Project: <u>Central Wastewater Treatment Plant</u>	Project Number: _____
Owner: <u>City of Pflugerville</u>	<u>88</u>
Contractor: <u>BAR Constructors, Inc</u>	<u>279</u>
Engineer: <u>Freese and Nichols, Inc</u>	<u>PFL16607</u>
Change Proposal No.: <u>CP0003</u> Description: <u>Structural Support Changes</u>	
Specification: <u>05 53 00 Metal Gratings</u>

Re: City of Pflugerville, Texas
Central WWTP Expansion Phase I Improvements
Project No. PFL16607
CP003r1 Cody Builders – Embeds Material Change

CHANGE ORDER

This change order request includes change of aluminum support beams at S-AS-6, S-AS13, additional aluminum support beams at S-HW-11 per RFI009 and cable trench embeds material change from galvanized to aluminum per submittal response.

Partial Plan - Mixed Liquor Junction Box Grating Layout
 3/8"=1'-0"
 (1 Req'd)
 Ref. Dwg #: Contract Drawing M-AS-8 & S-AS-9

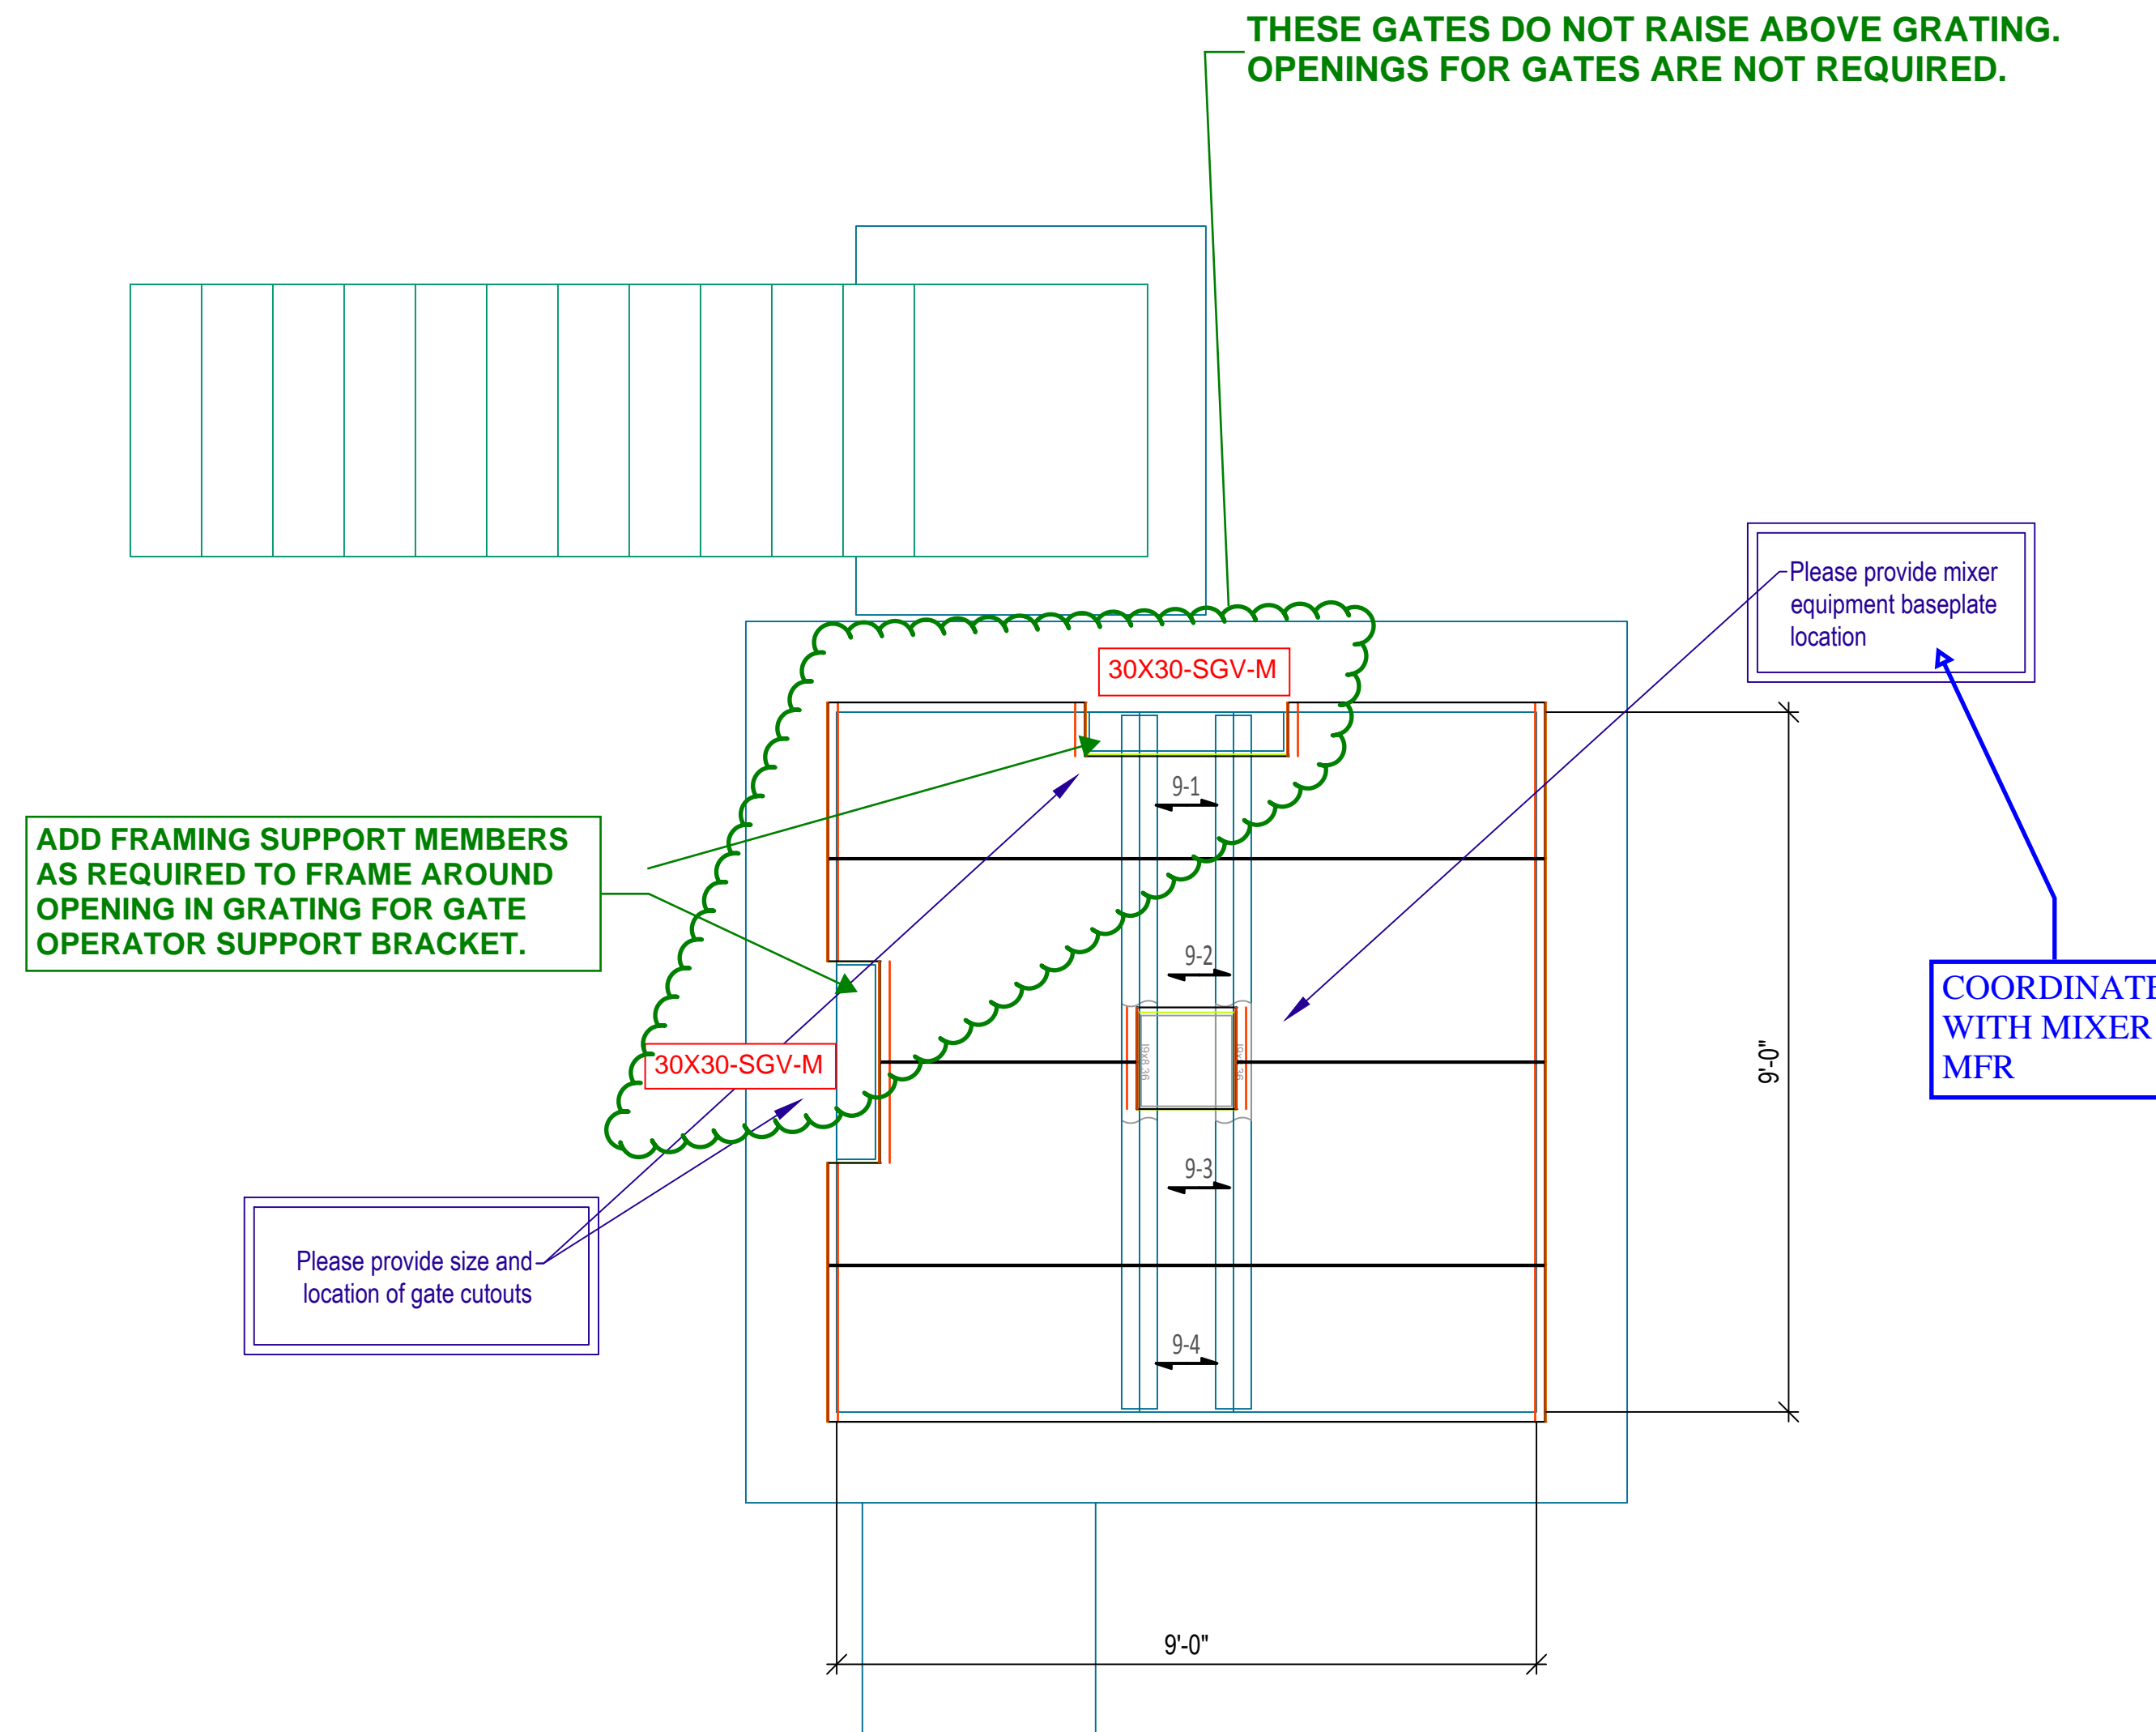
Please provide size and location of gate openings
 Typical (4) places

COORDINATE WITH MFR TO ENSURE PROPER CLEARANCE

ADD FRAMING SUPPORT MEMBERS AS REQUIRED TO FRAME AROUND OPENING IN GRATING FOR GATE OPERATOR SUPPORT BRACKET. TYPICAL AT ALL GATES.

Partial Plan - Influent Lift Station Grating Layout
 (1 Req'd)

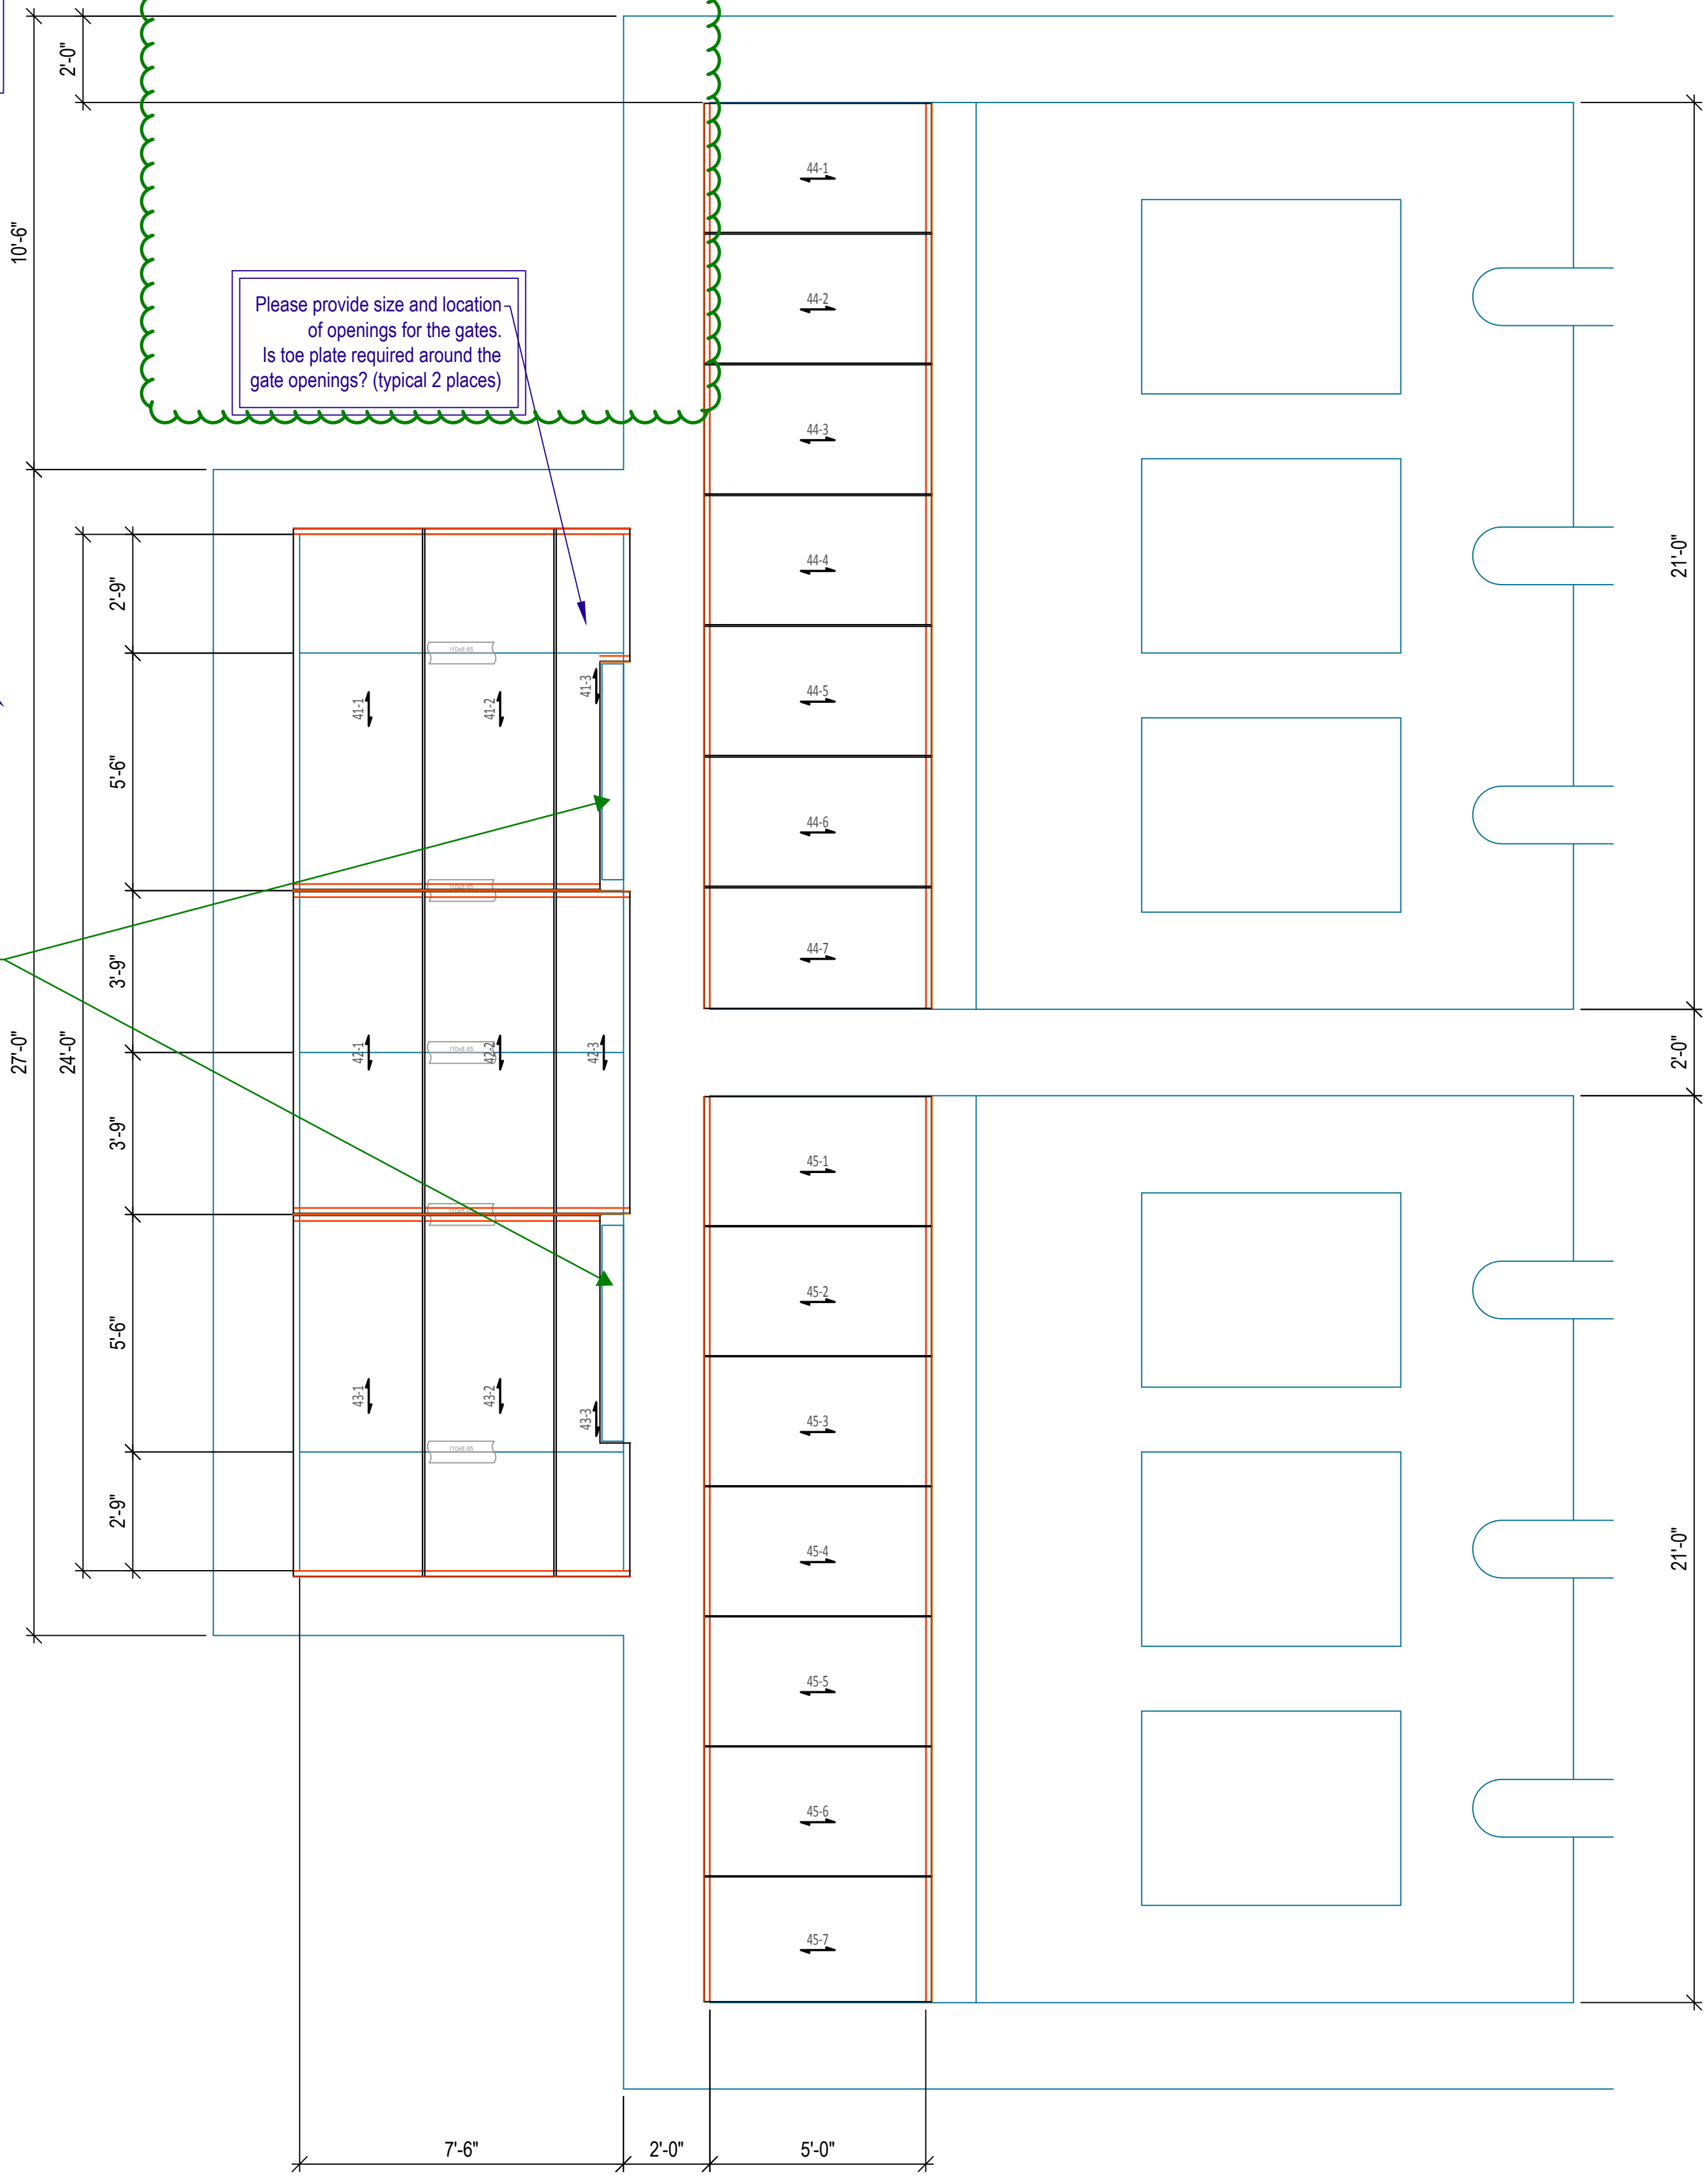
Please provide size and location of openings for the gates. Is toe plate required around the gate openings? (typical 2 places)

THESE GATES DO NOT RAISE ABOVE GRATING.
 OPENINGS FOR GATES ARE NOT REQUIRED.

ADD FRAMING SUPPORT MEMBERS AS REQUIRED TO FRAME AROUND OPENING IN GRATING FOR GATE OPERATOR SUPPORT BRACKET. TYPICAL AT ALL GATES.

Partial Plan - Headworks Screening Facility Grating Layout
 (1 Req'd)

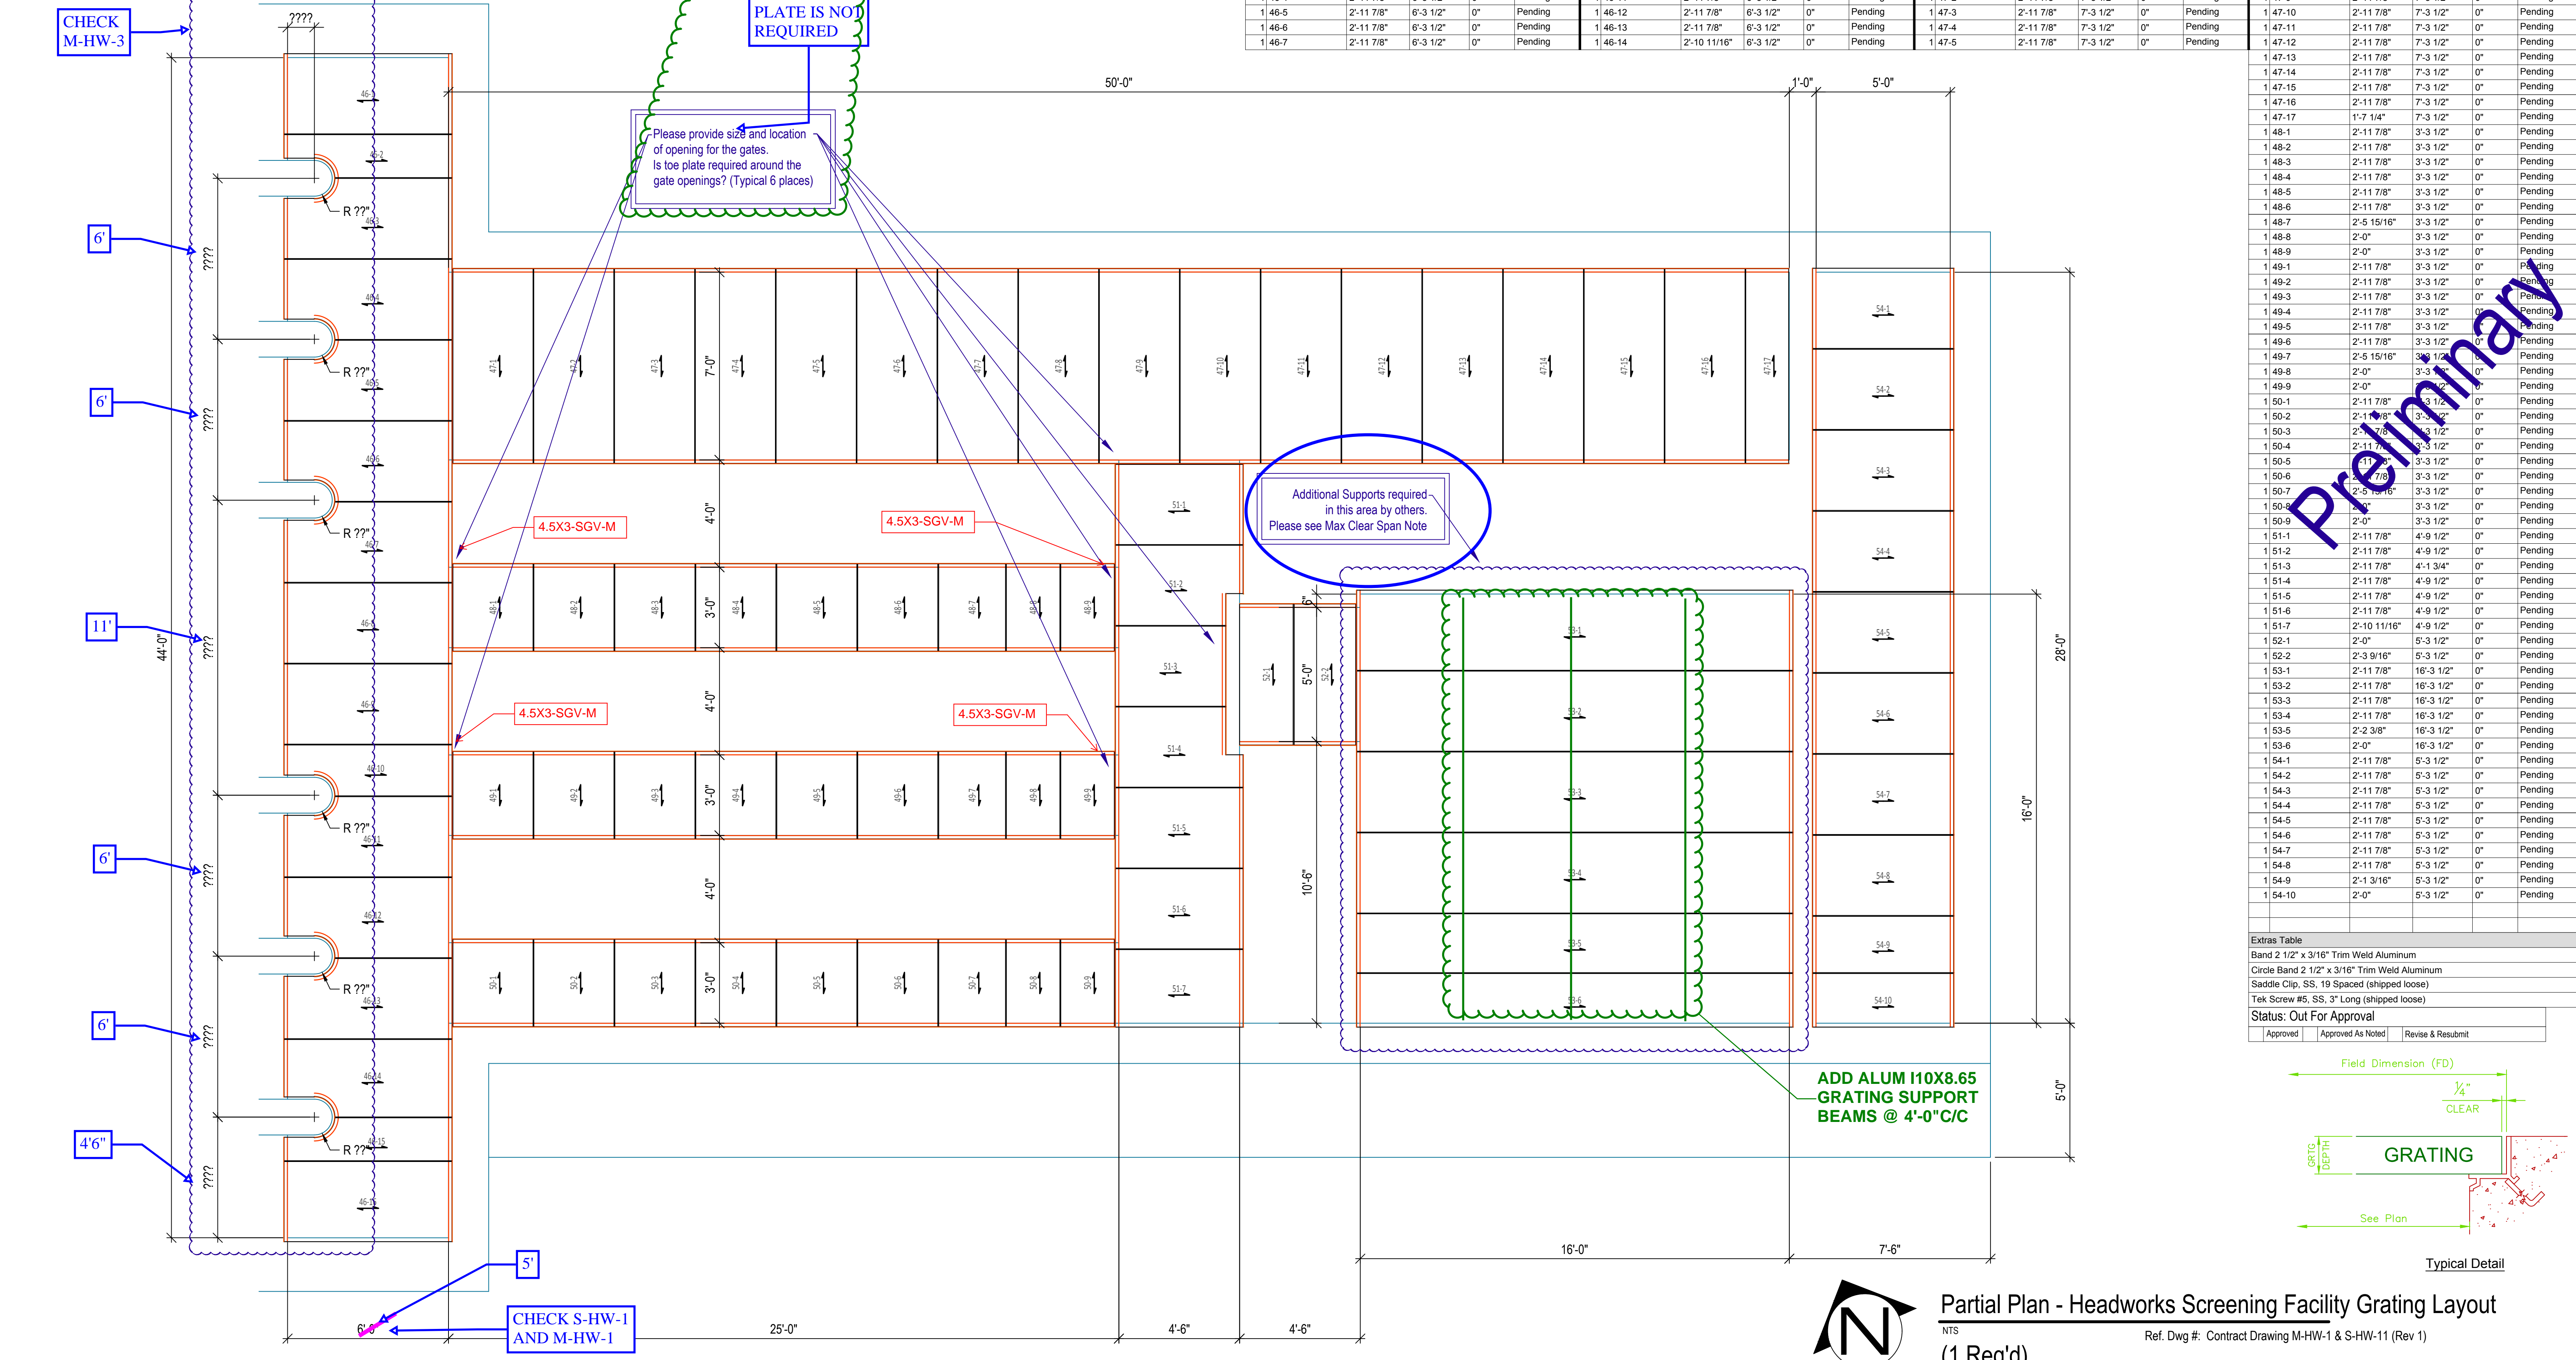
Please provide size and location of cutouts. Is toe plate required around the pipe cutouts? (Typical 6 places)

Please provide size and location of opening for the gates. Is toe plate required around the gate openings? (Typical 6 places)

VERIFY IF THESE GATES RAISE ABOVE GRATING. OPENINGS FOR GATES ARE NOT REQUIRED IF GATES DO NOT RAISE ABOVE GRATING. COORDINATE WITH GATE MFR.
